U.S. GEOLOGICAL SURVEY
RESEARCH REACTOR
LICENSE NO. R-113
DOCKET NO. 50-274

U.S GEOLOGICAL SURVEY LETTER
RESPONSE TO RAI NO 8 AND 9
NOVEMBER 30, 2011

Subject: Response to Questions 7 and 8 of the Referenced RAI

Figure 1: Example of heat structure nodes in RELAP5

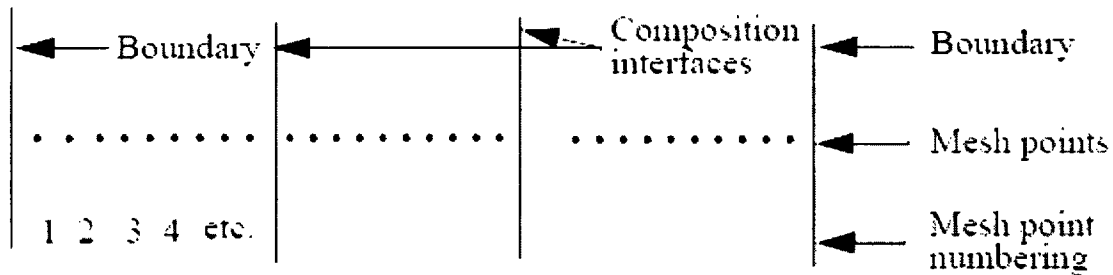
Question 8: NUREG 1537, Part 1 Section 4.5, “Nuclear Design,” requests a detailed description of analytical methods used in the nuclear design, including computer codes used to characterize technical parameters pertaining to the GSTR. The GSTR SAR has not provided such information. Please provide descriptions of the analytical methods employed in Sections 4.5.1 through 4.5.6 of the application to calculate power distributions, reactivity coefficients, control rod worths, and Departure from Nucleate Boiling Ratio (DNBR).

Heat structures use a one-dimensional heat-transfer approximation to represent heat flow through solid mediums within a RELAP deck. Either a rectangular or cylindrical geometry can describe the heat structure. A series of nodes represent solid material, as shown in Figure 1. Aside from the nodes for a one-dimensional analysis, multiple sets of nodes can be connected axially (although heat does not transfer from one set of nodes to another) to represent more complex structures. Multiple axial nodes are required when connecting a single heat structure to multiple hydraulic components (such as those in a PIPE) as each heat structure can only connect to a single hydraulic component. Multiple materials can

be represented within a single heat structure as long as the thermal data (thermal conductivity and volumetric heat capacity) for each material is provided by the user. RELAP allows for this data input through tables, equations, or as a constant value (Information Systems Laboratories, Inc., 2010).
